ADDENDUM NO. 4

January 30, 2023

Three Rivers Community Schools – Three Rivers Middle School Additions and Renovation

This Addendum consists of Pages ADD 4-1 through ADD 4 - 3, Attached RFI Log, Substitution Request, and GMB Architecture and Engineering Addendum No. 4, dated January 26, 2023, consisting of 4 pages, Reissued Specification Sections; 08 71 00 – Door Hardware, 09 22 16 – Non-Structural Metal Framing, and 09 65 19 - Resilient Tile Flooring, New Sheet; S3.1E, and Reissued Sheets; G0.00, G1.01, G2.01, C8.01, A1.1E, A2.1E, A2.30, A5.01, A6.01, A7.03, A8.01, A8.02, M1.1D, M1.1E, M1.81, M2.1C, M2.1D, M2.1E, M3.1D, M8.01, M8.03, M8.04, M9.01, M9.02, E1.1C, E1.1D, E2.1D, E2.1E, and E7.01.

1
M2.1D
ENLARGED UNIT 'D' MECHANICAL MEZZANINE HVAC PLAN
1/4" = 1'-0"

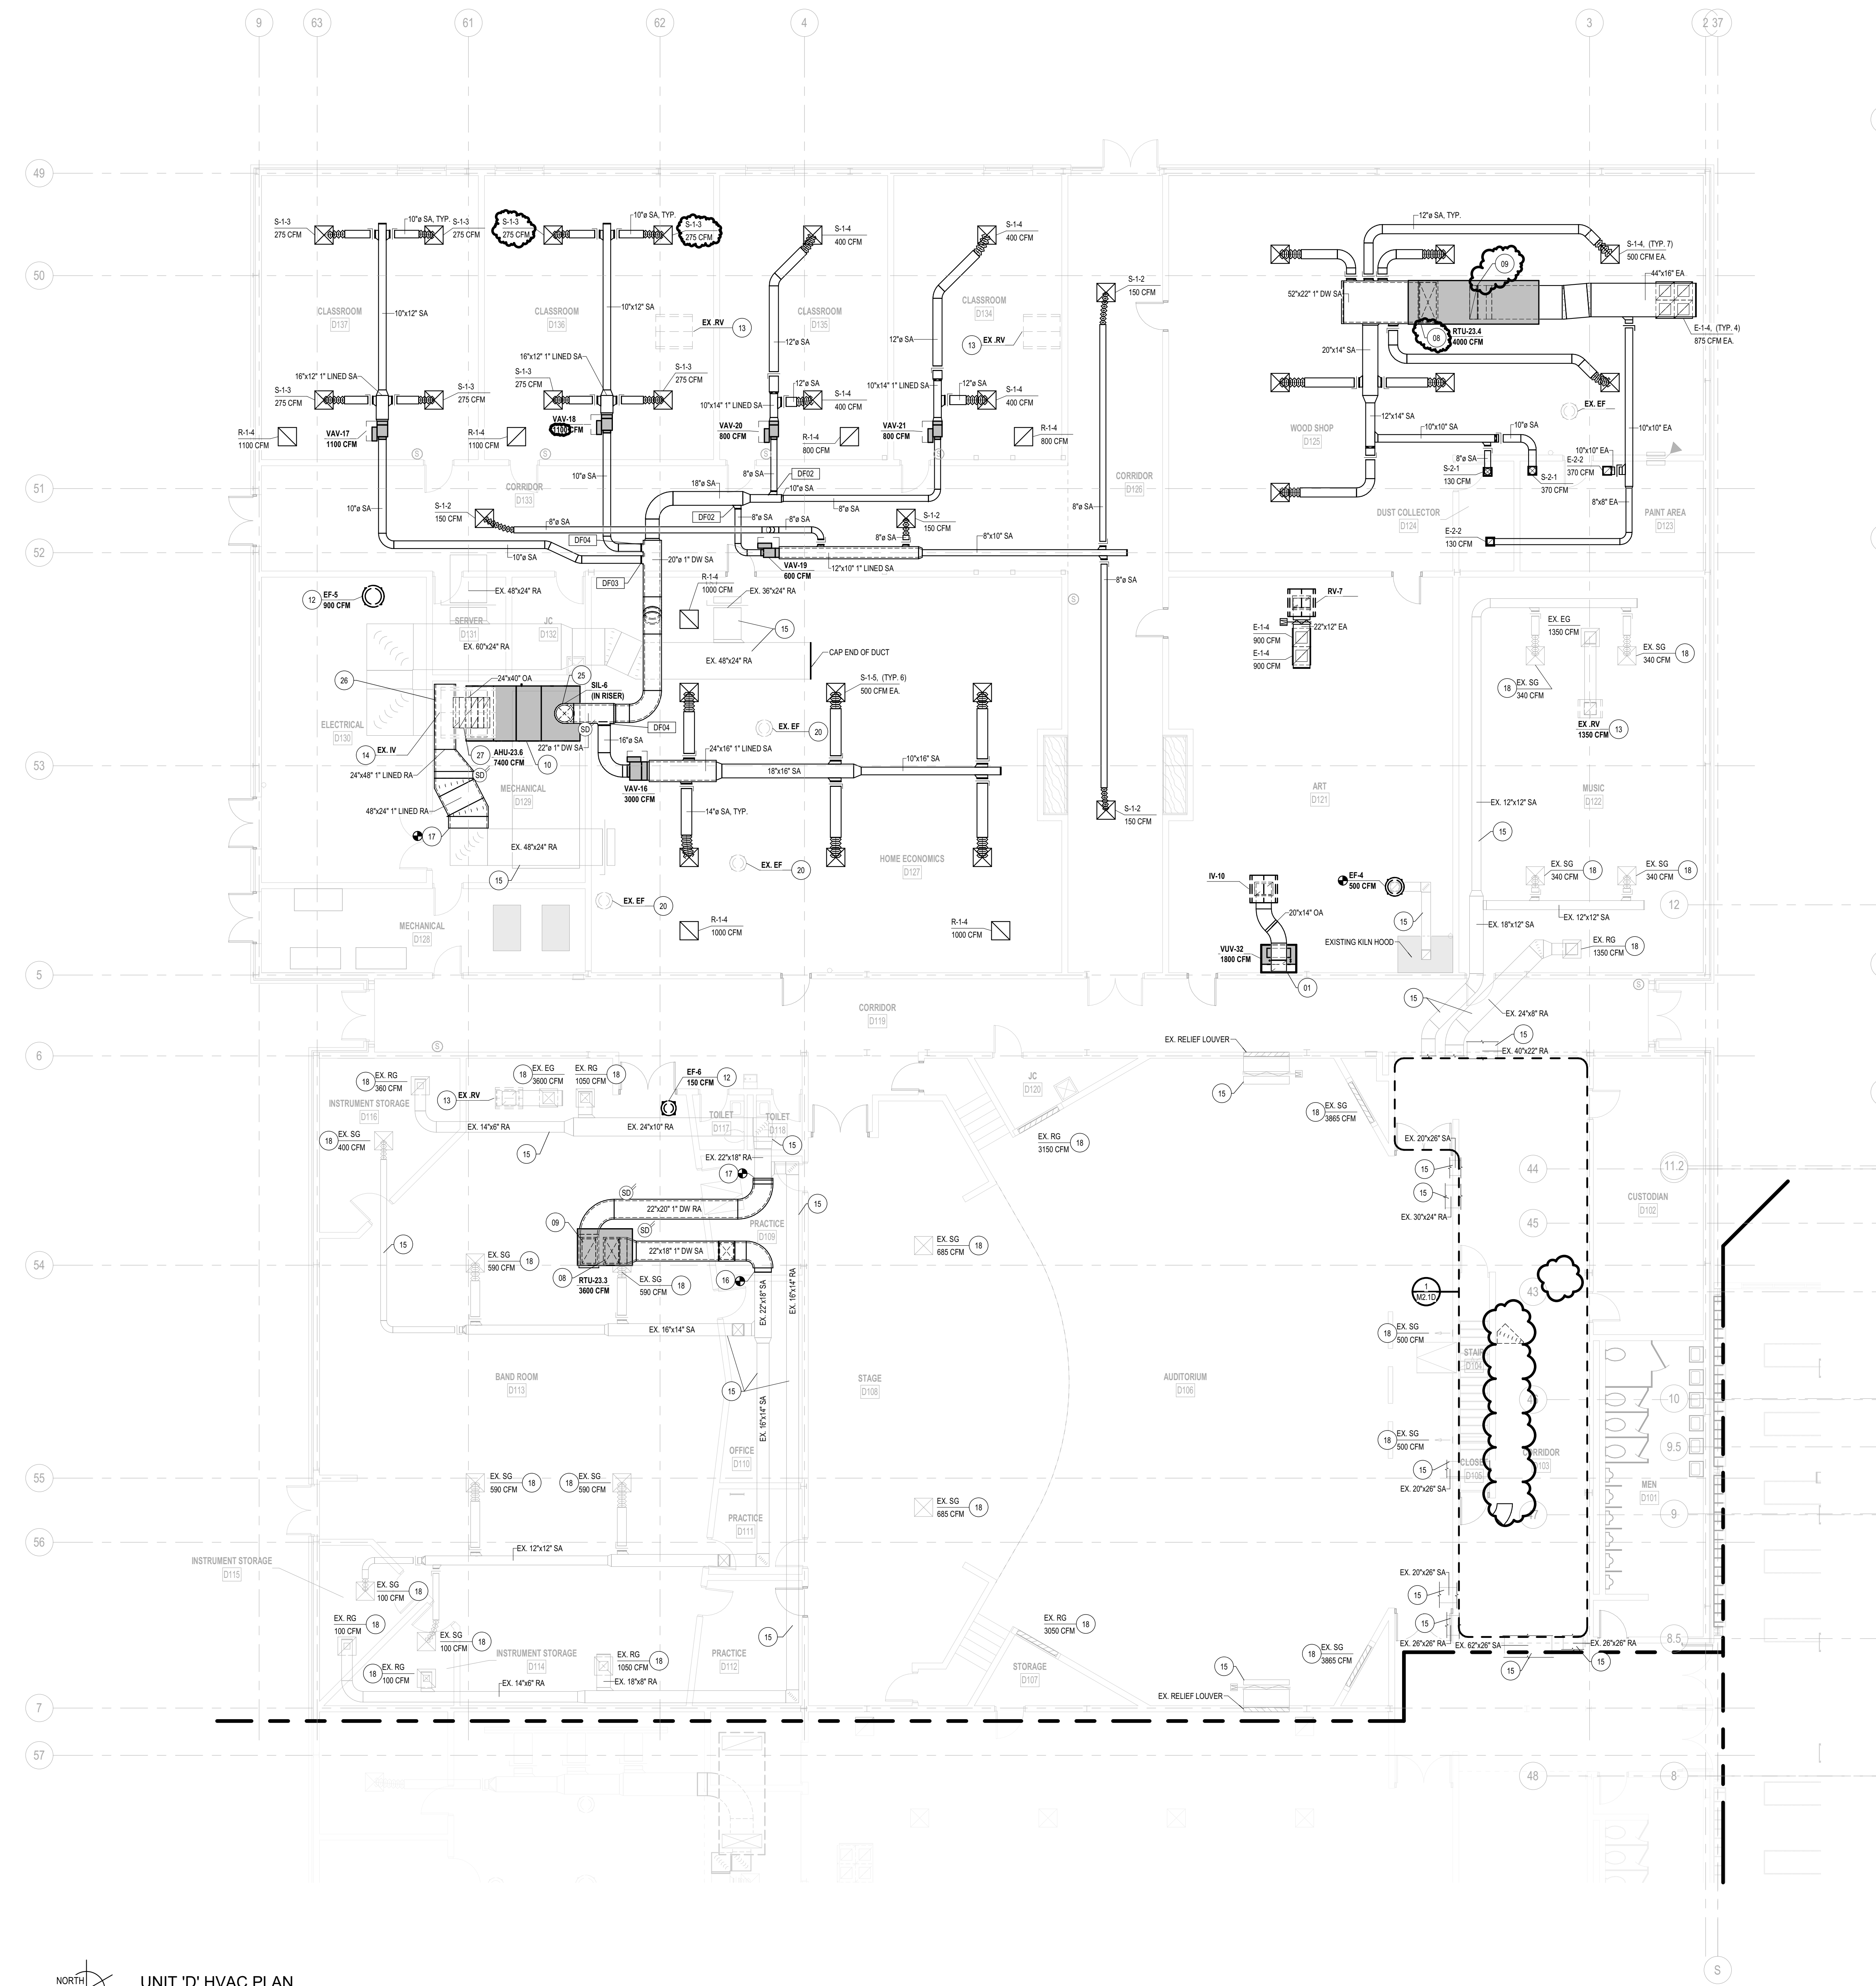
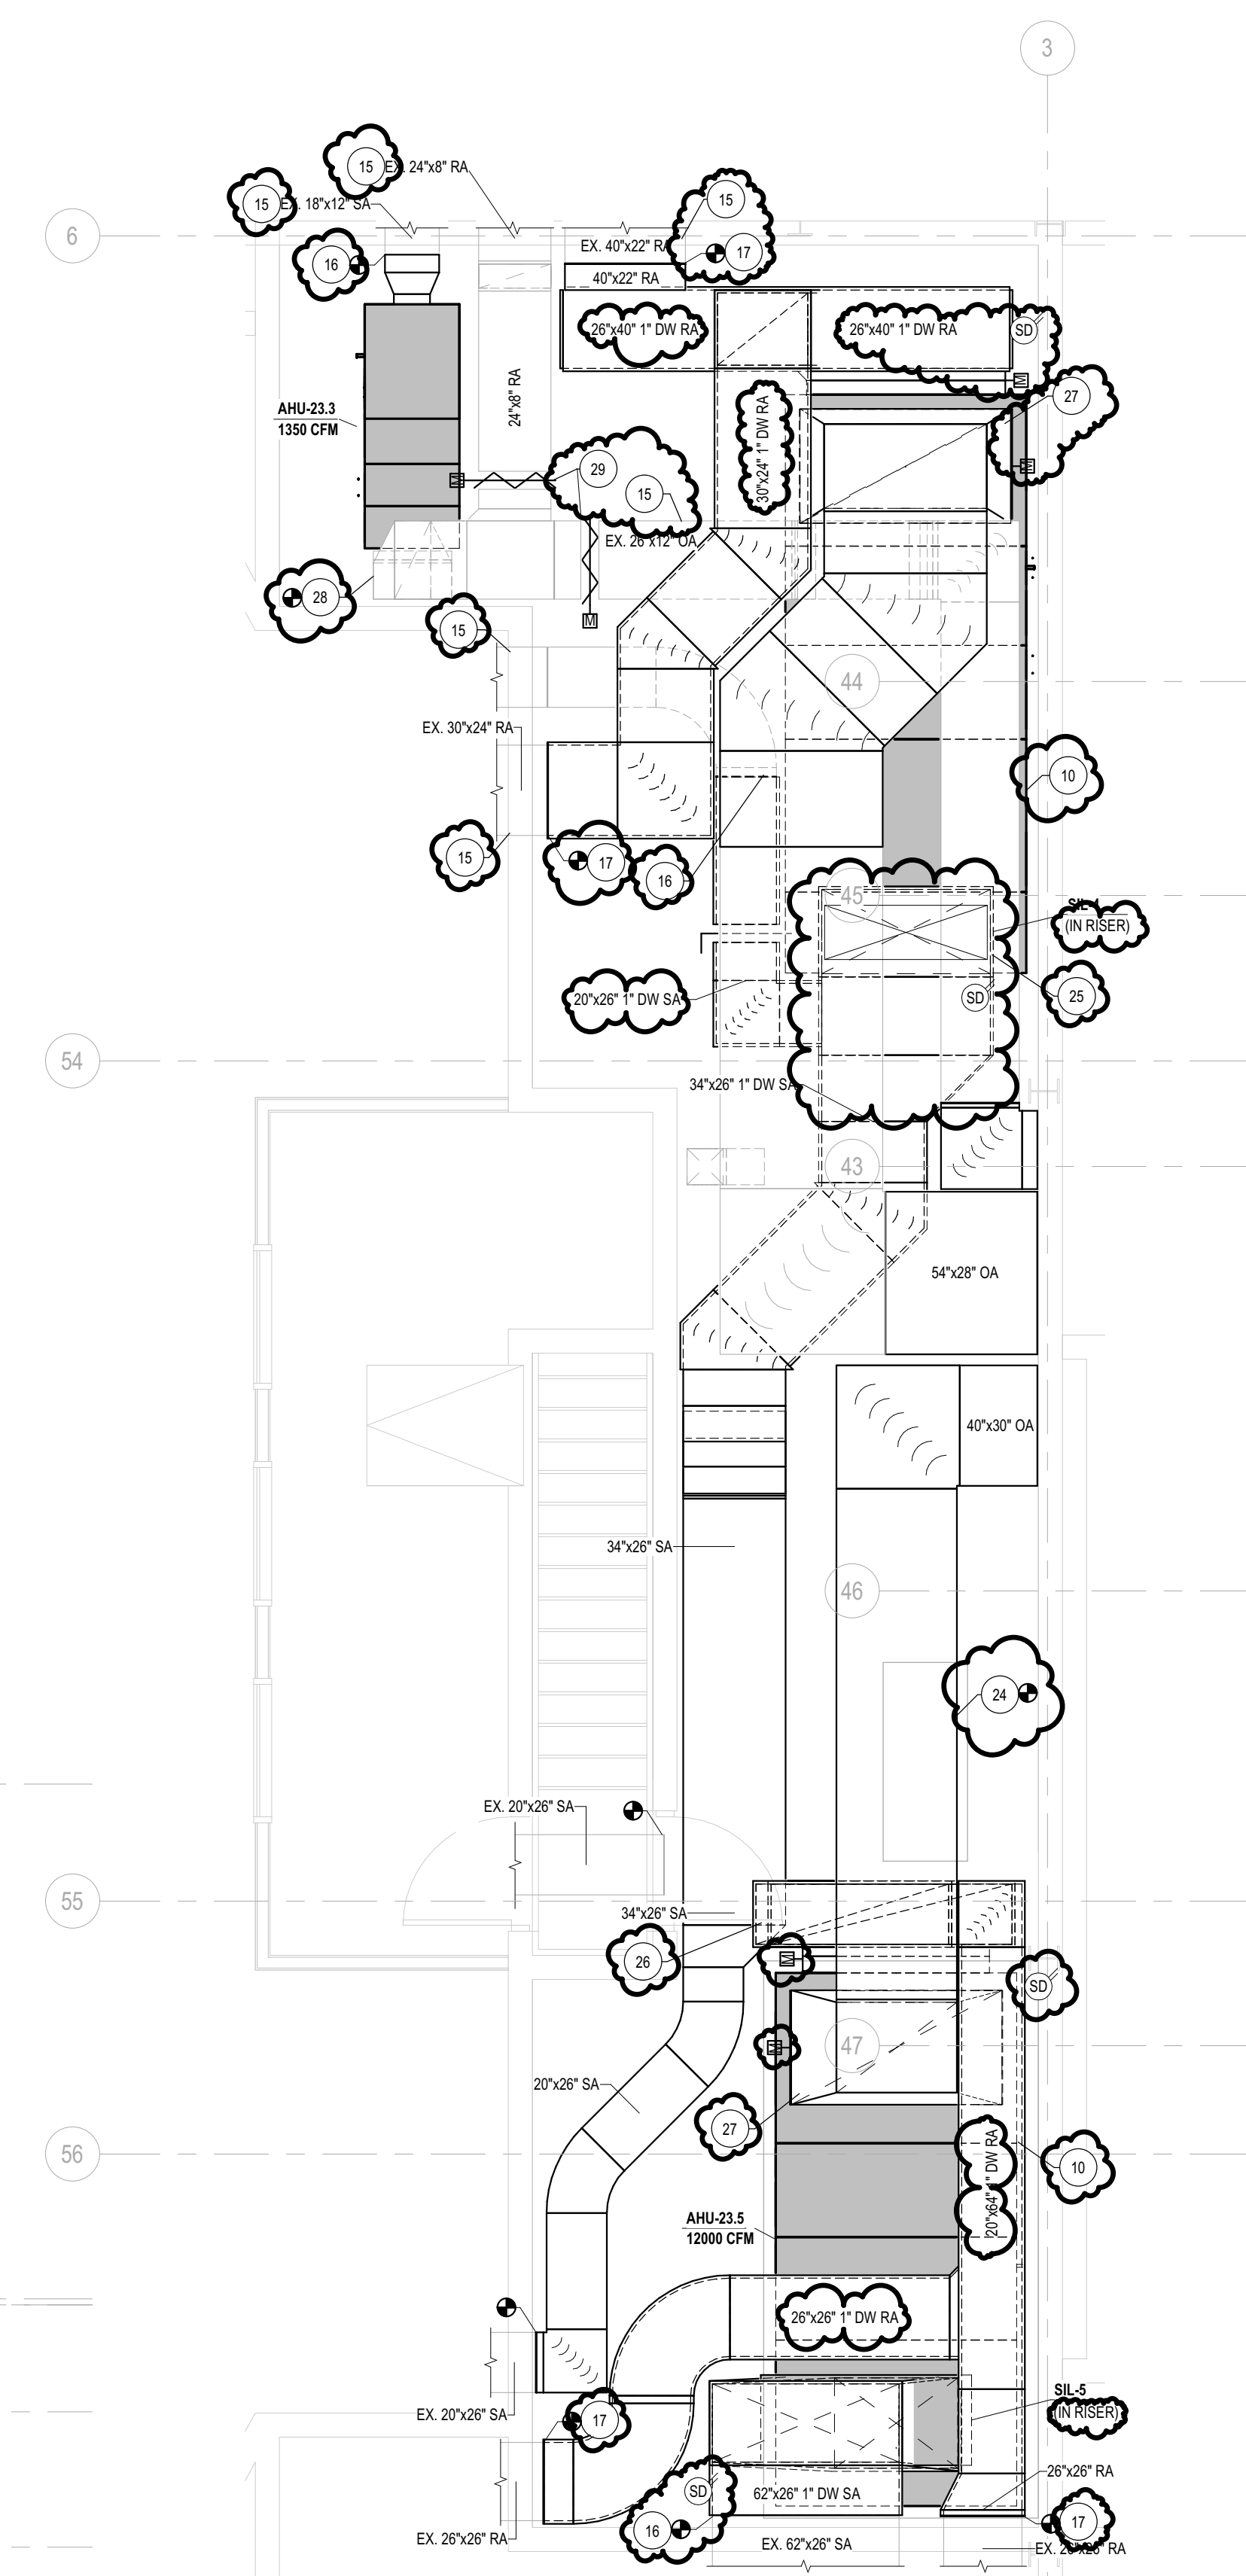
- A. Added and revised mechanical keynotes.
- B. Revised Mechanical Keynote Legend.

NORTH
UNIT 'E' HVAC PLAN
1/8" = 1'-0"

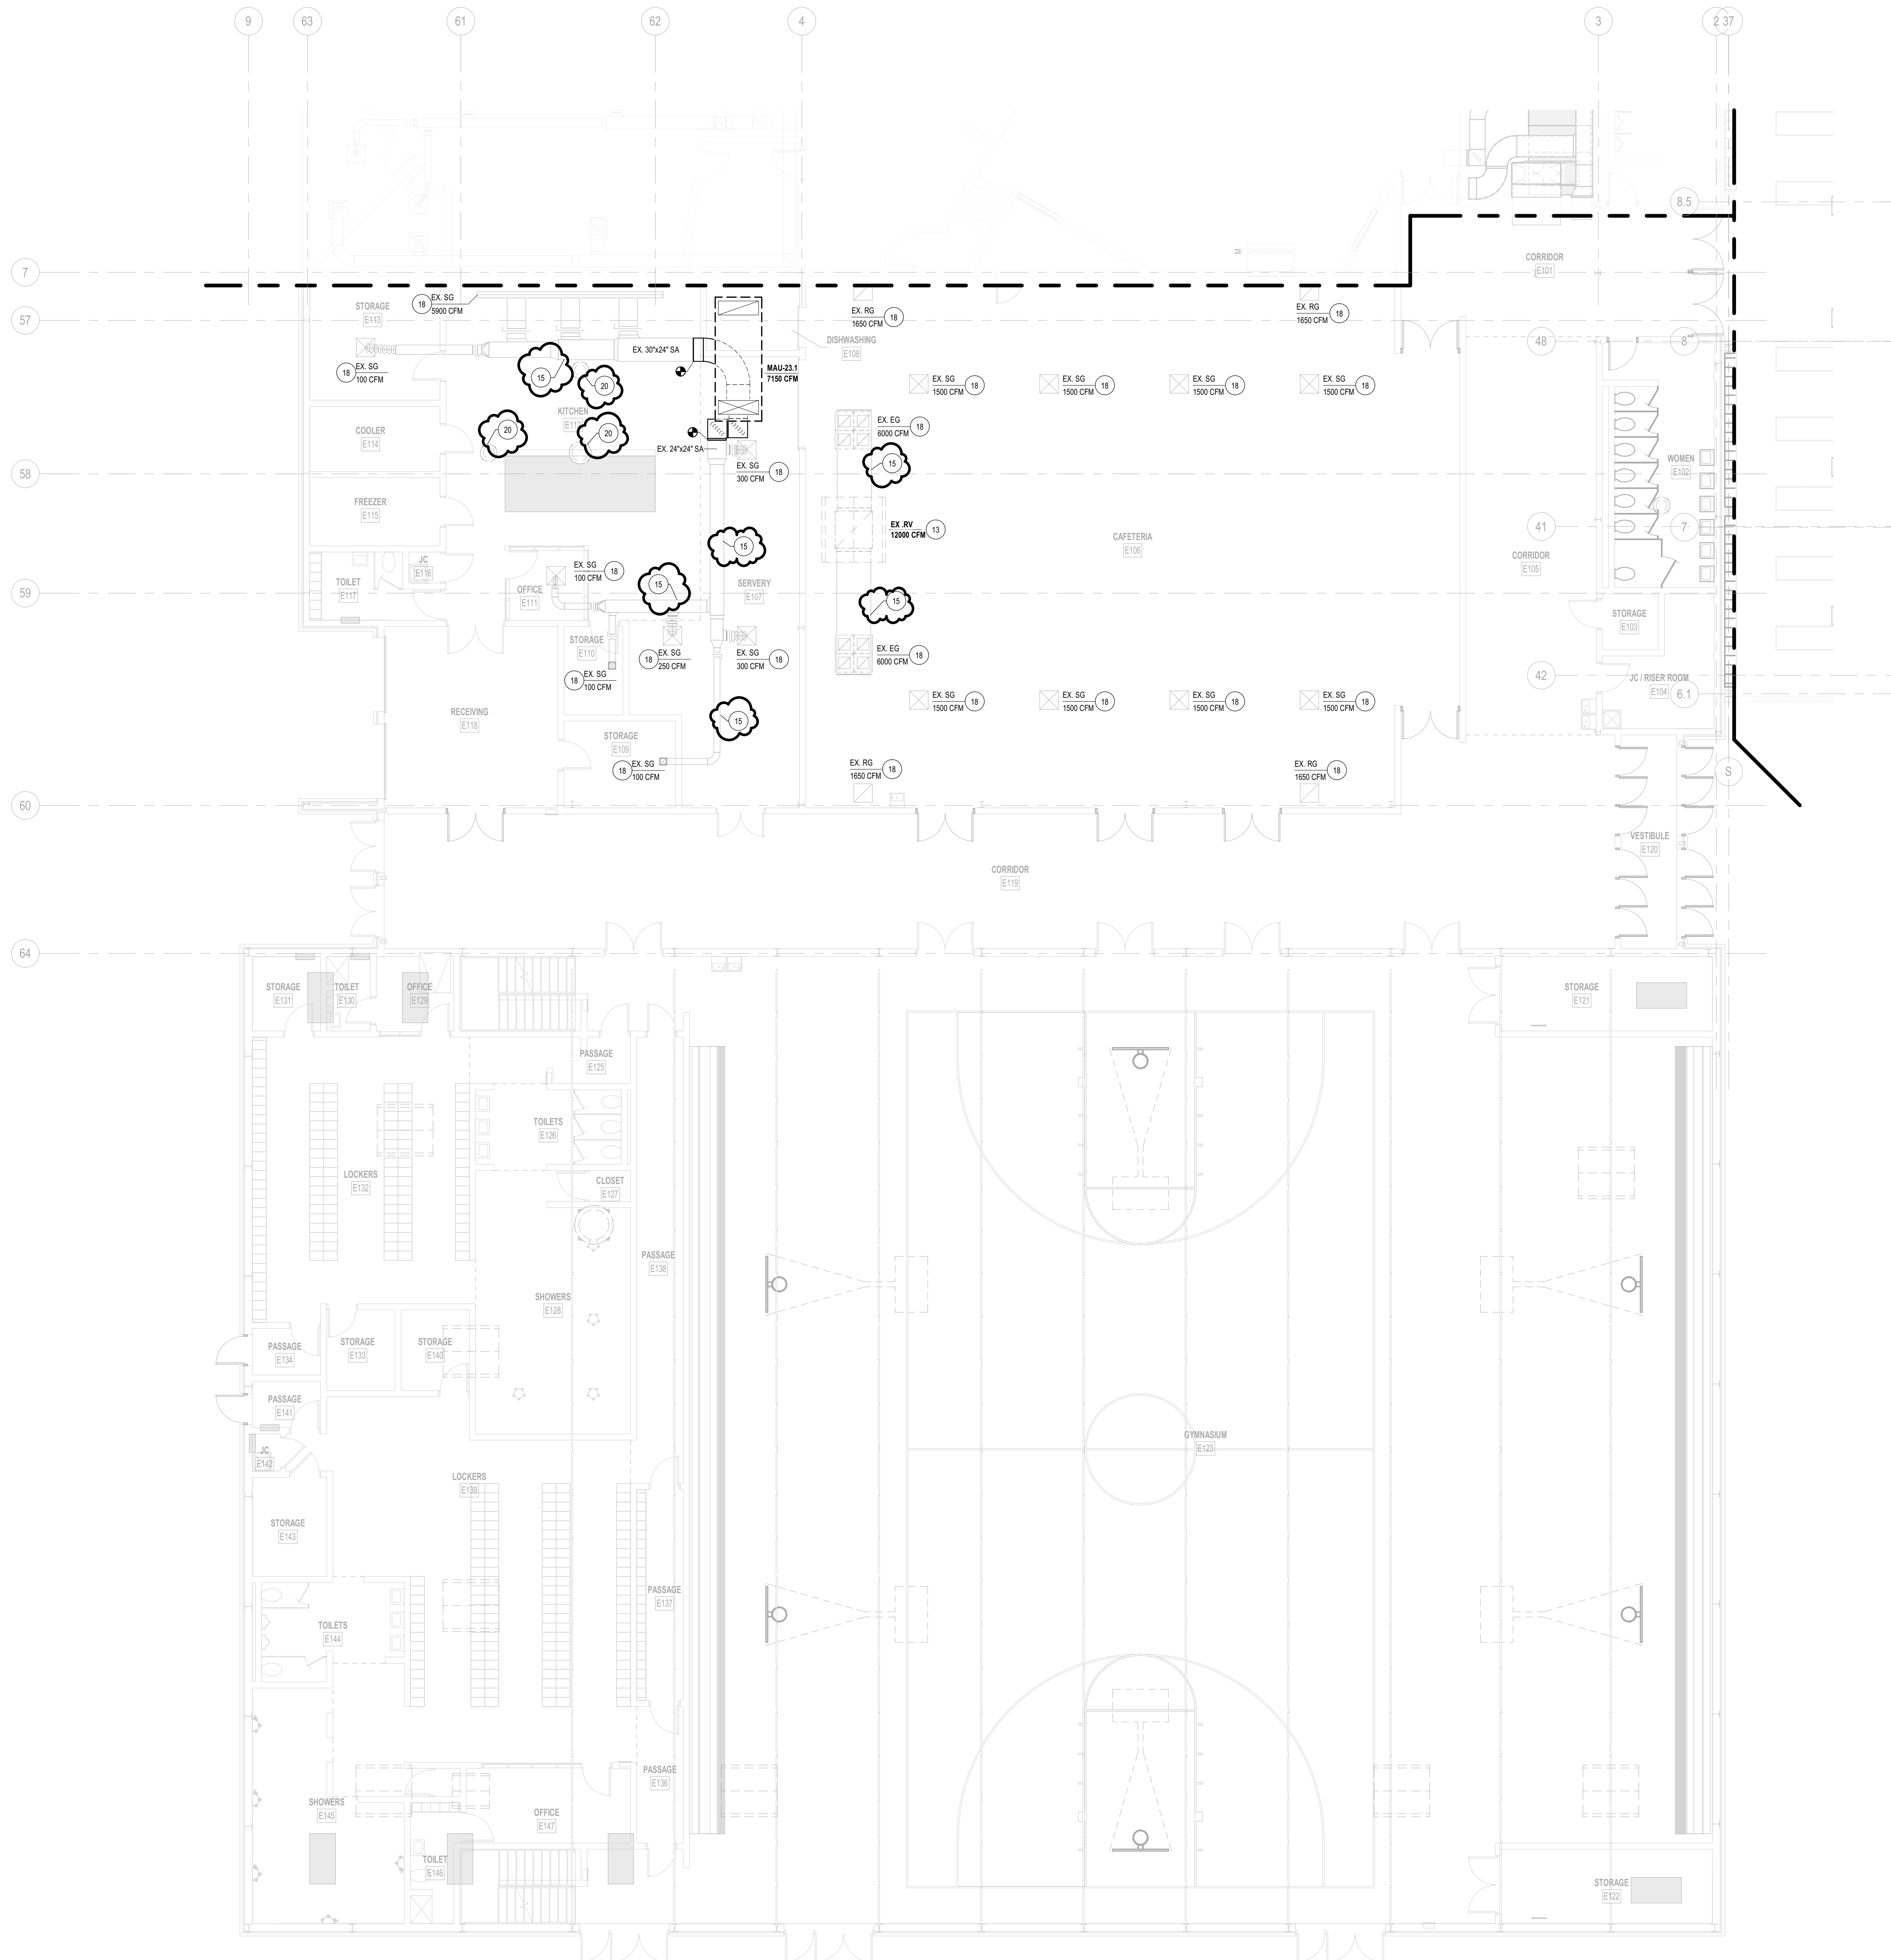
- A. Added mechanical keynotes.
- B. Revised Mechanical Keynote Legend.
